# Cowle St, West Perth - Multiple Dwelling Apartments

## Sustainability Services
## NCC Section J NatHERS Report
## Cost Plan 1 Issue

**Alex Murphy**
Project No. 29398
\\WGE-PER-FS-01\PROJECTS\29398\PROJECT DOCUMENTATION\SUSTAINABILITY\SECTION J\29398_G_NATHERS_COWLE ST_REV 2.DOCX

**Reduced Balcony Insulation:**

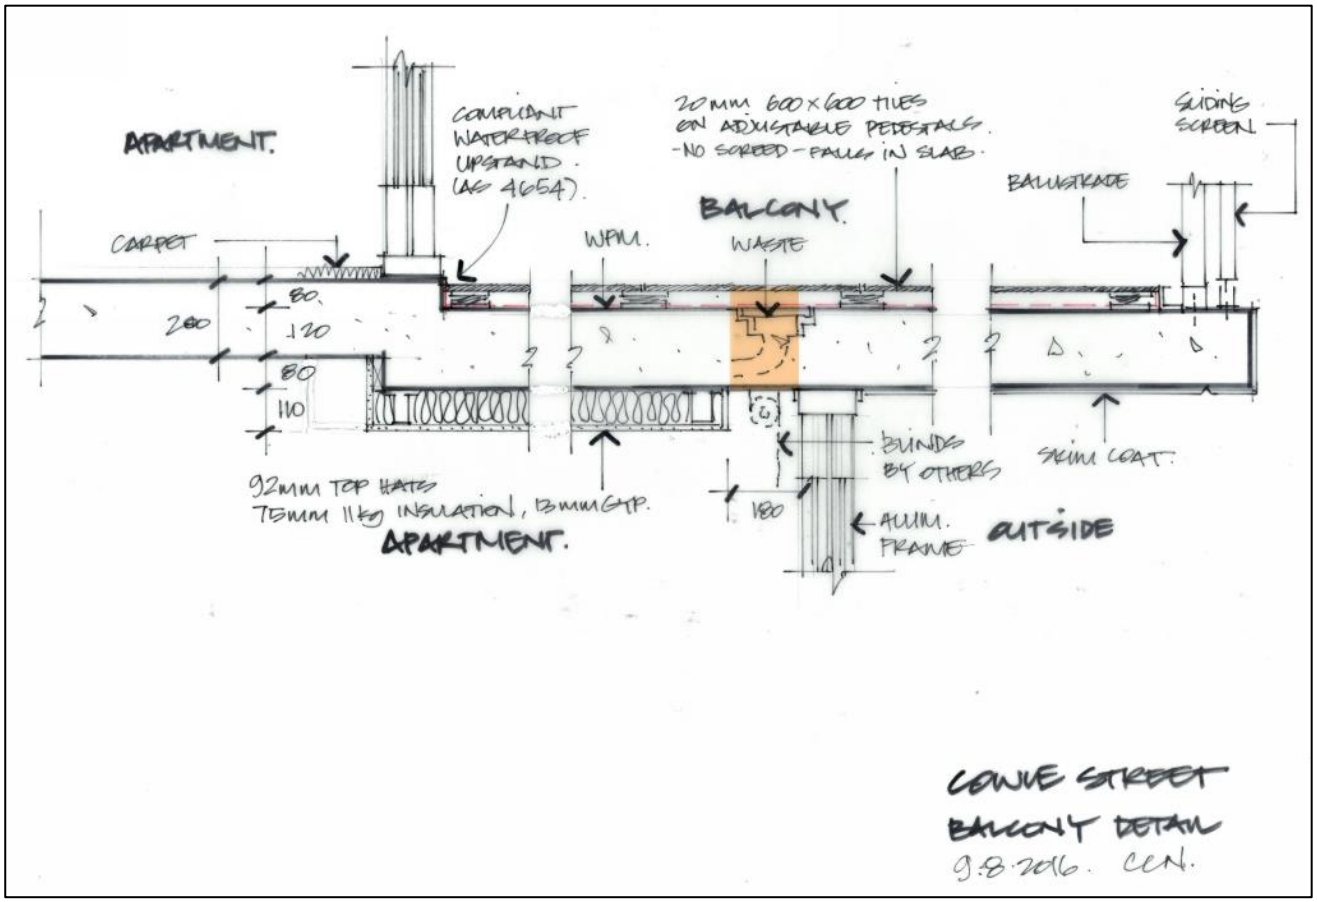
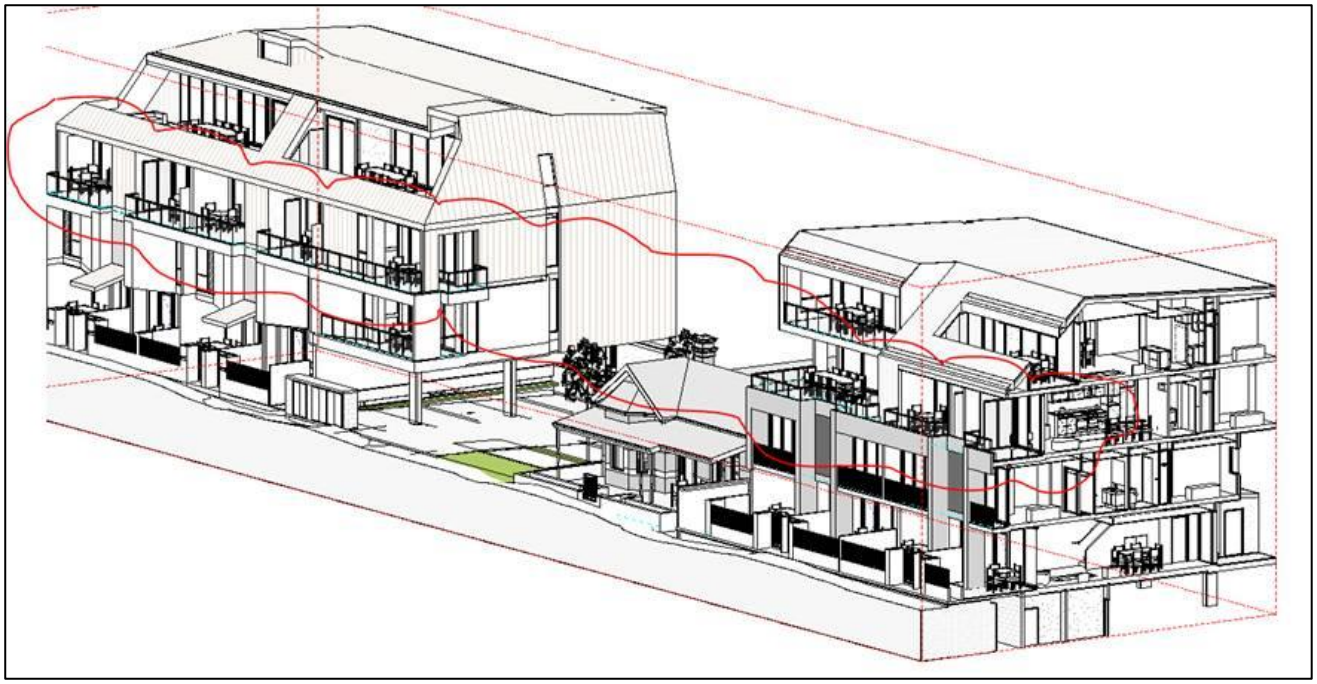
Please see mark-ups below that show a section of no insulation on a balcony for the full width of the sliding door (orange band). This reduction in insulation is required in order to keep the aluminum joinery running full height on the lower apartment.

Please see below the apartments which have been modelled with reduced insulation as per the below mark-ups:

TITLE
OVERALL SITE LAYOUT - BASEMENT & GROUND LEVELS

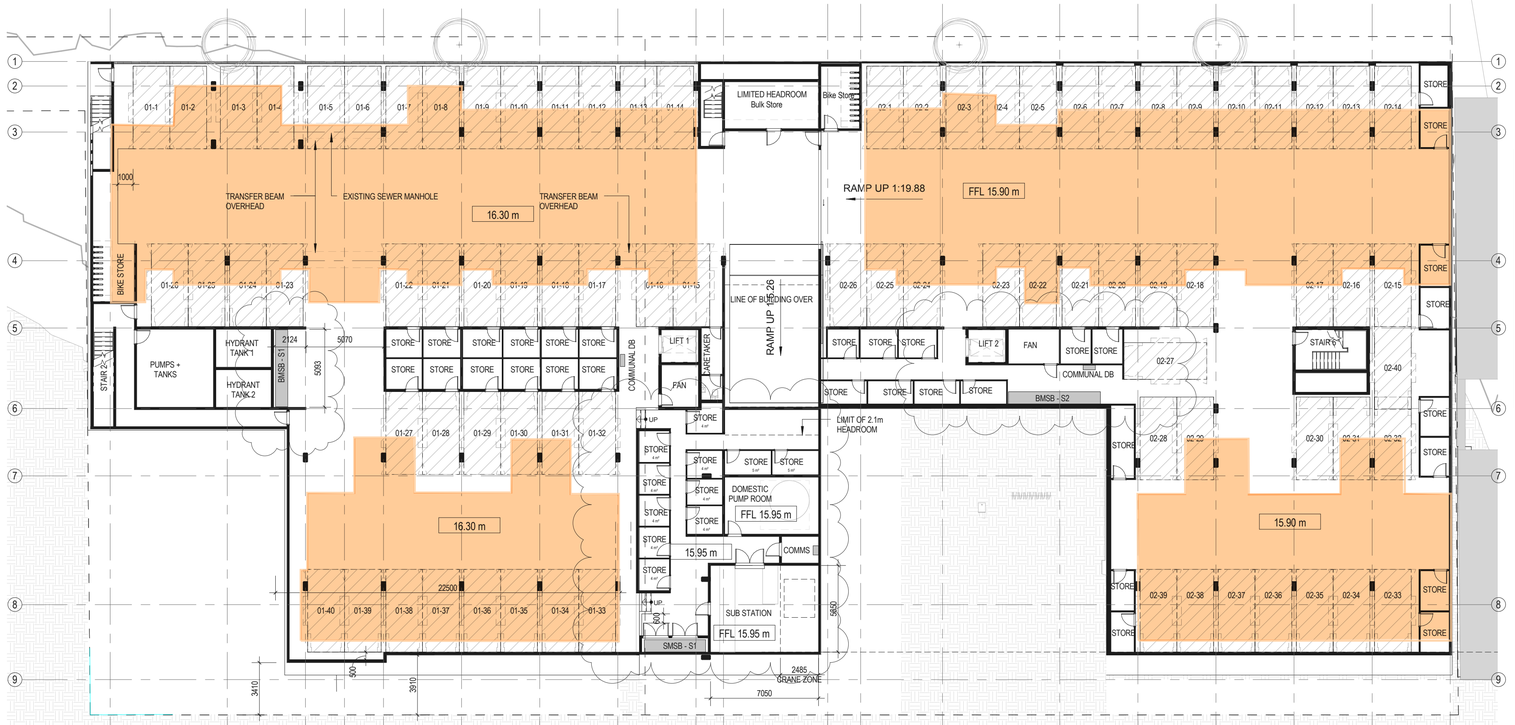
- Minimum Added Insulation R1.8 to Roof
- Minimum Added Insulation R2.0 to Exposed Floor
- Minimum Added External wall Insulation R2.0

TITLE
OVERALL SITE LAYOUT - LEVELS 1 & 2

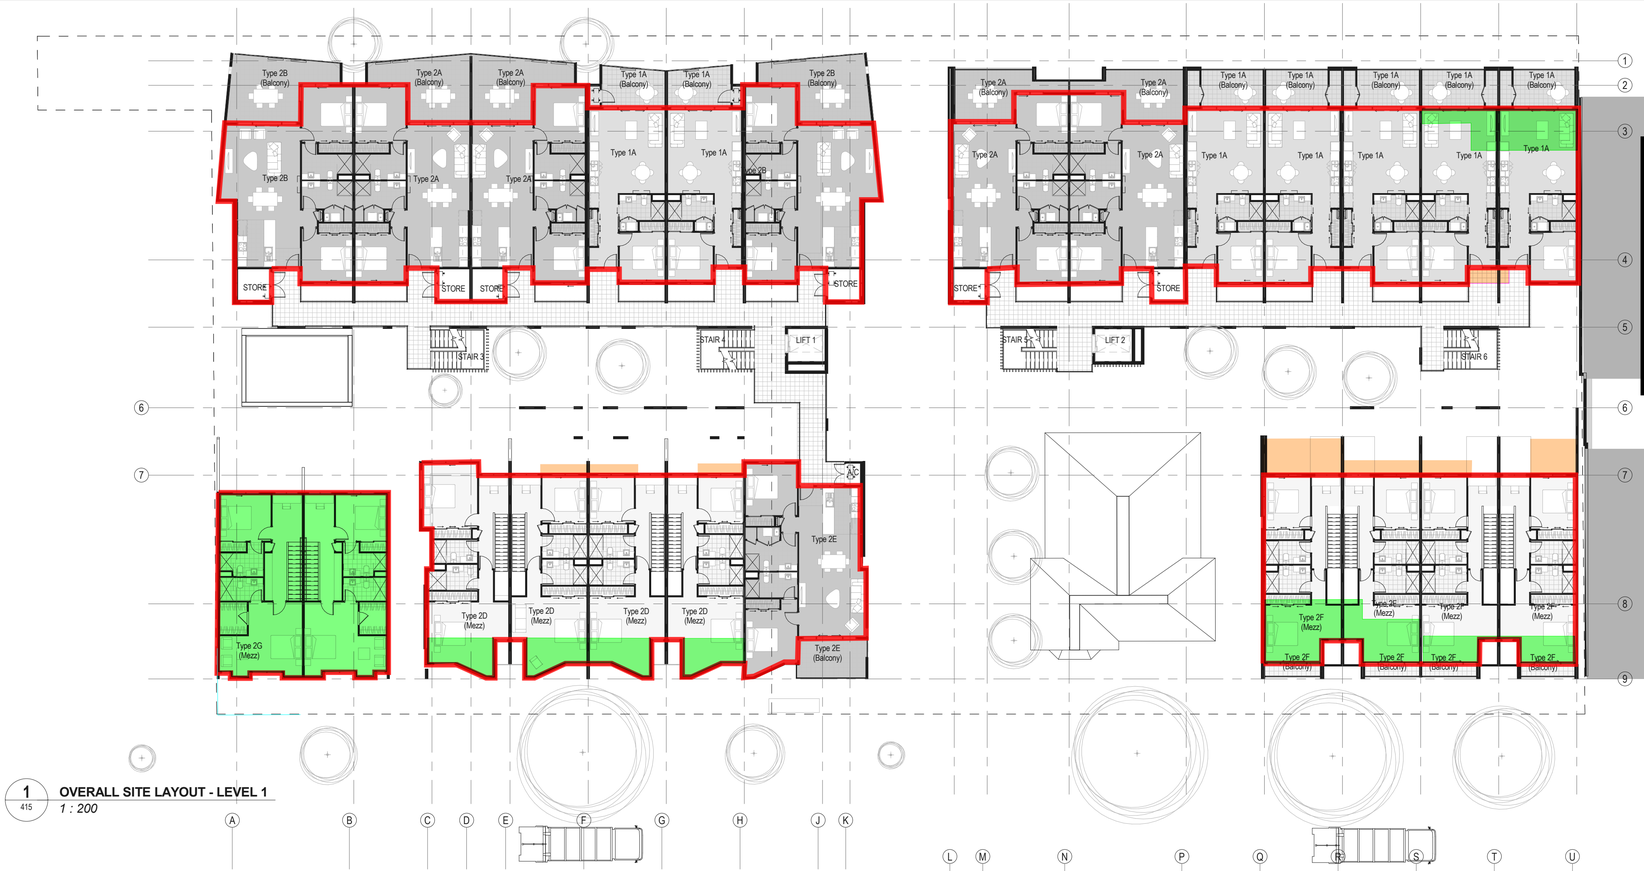
- Minimum Added Insulation R1.8 to Roof
- Minimum Added Insulation R2.0 to Exposed Floor
- Minimum Added External wall Insulation R2.0

TITLE
OVERALL SITE LAYOUT - LEVEL 3 & ROOF

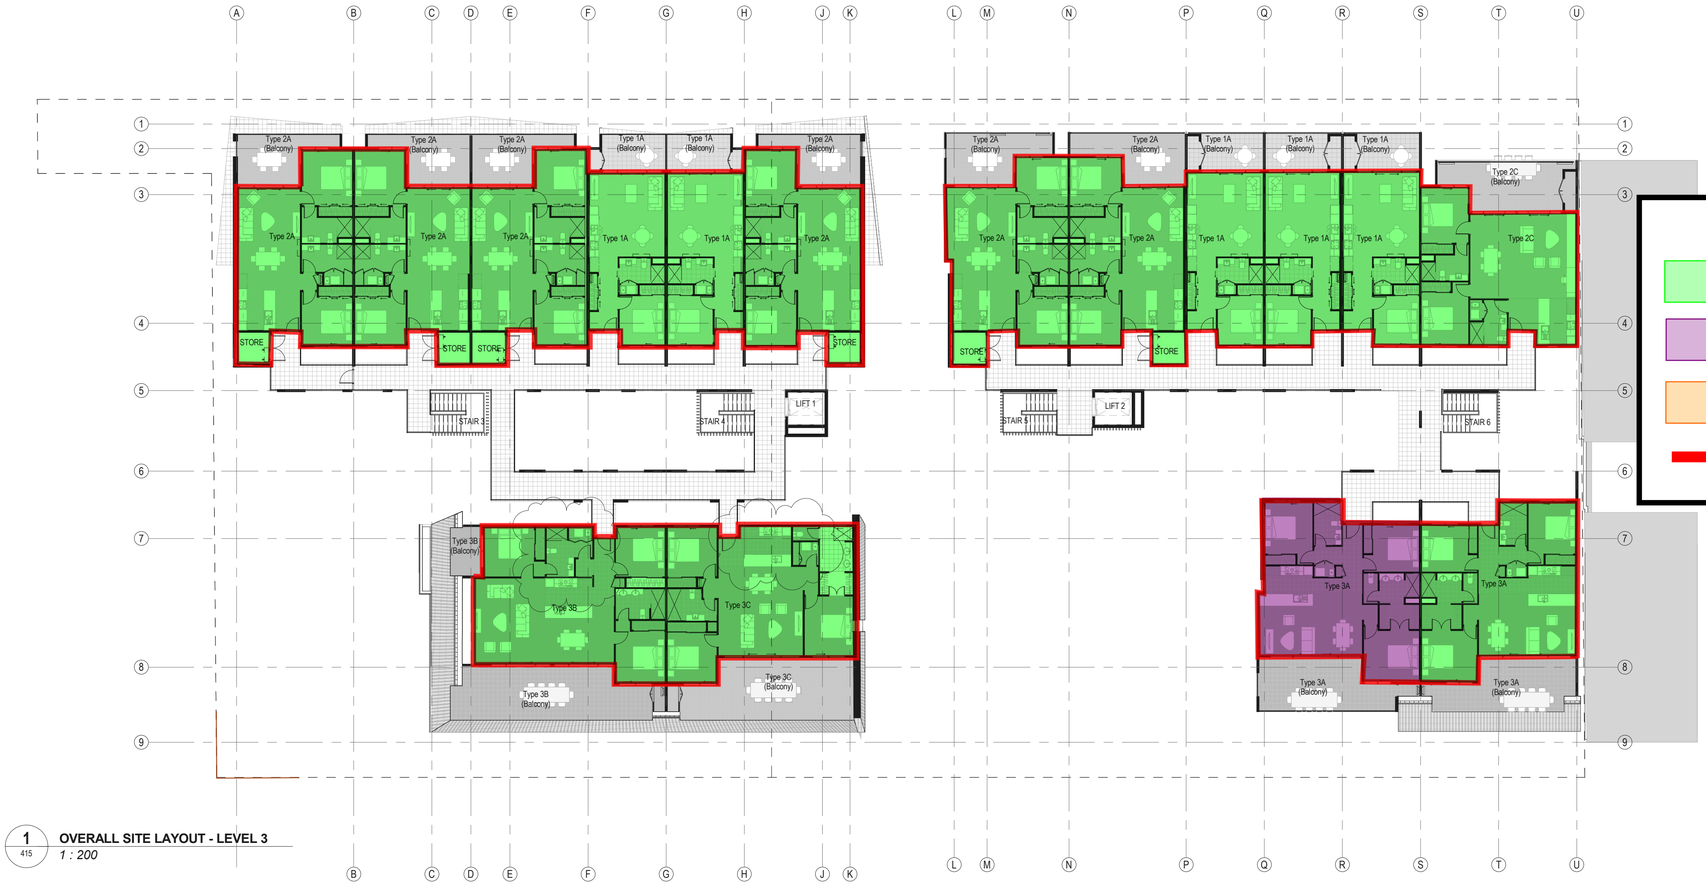
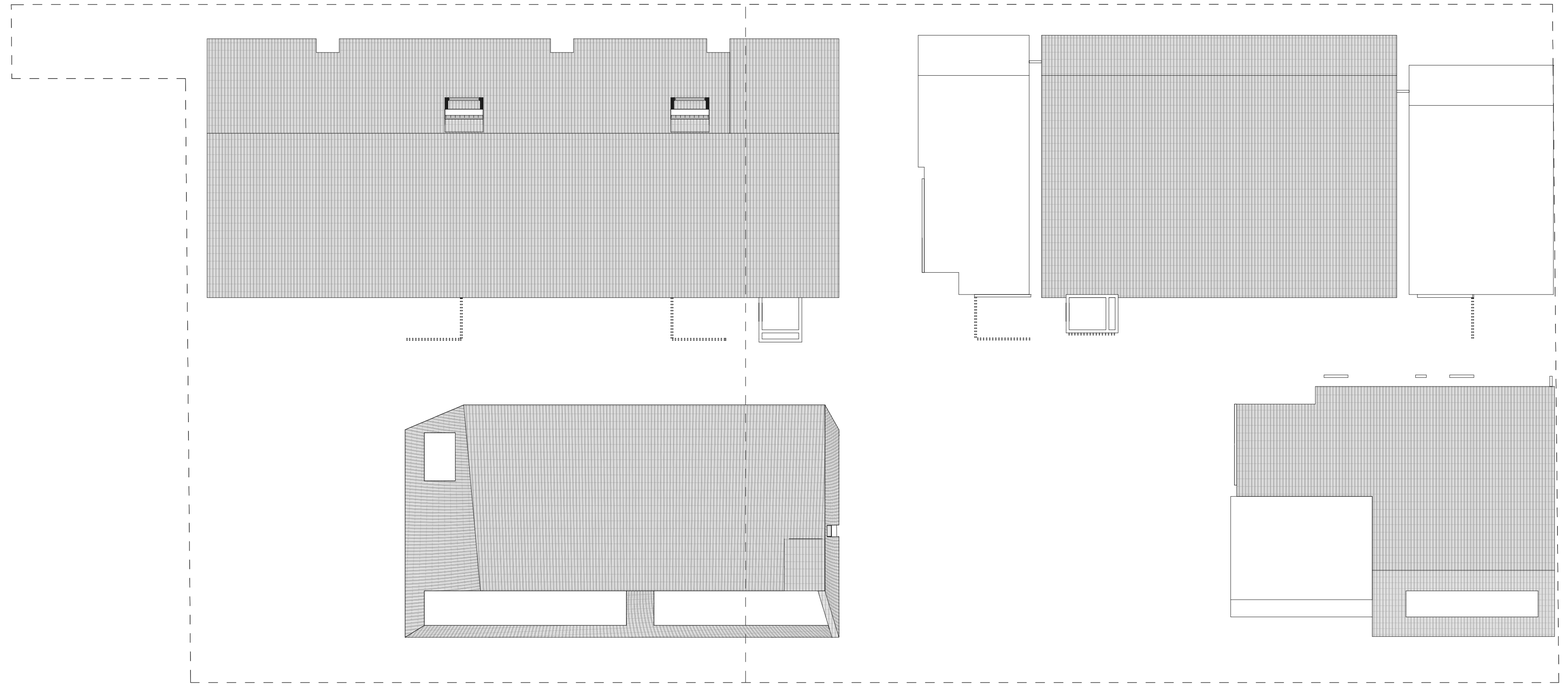
- Minimum Added Insulation R1.8 to Roof
- Minimum Added Insulation R1.8 to Roof + R0.5 Added Insulation to Ceiling
- Minimum Added Insulation R2.0 to Exposed Floor
- Minimum Added External wall Insulation R2.0
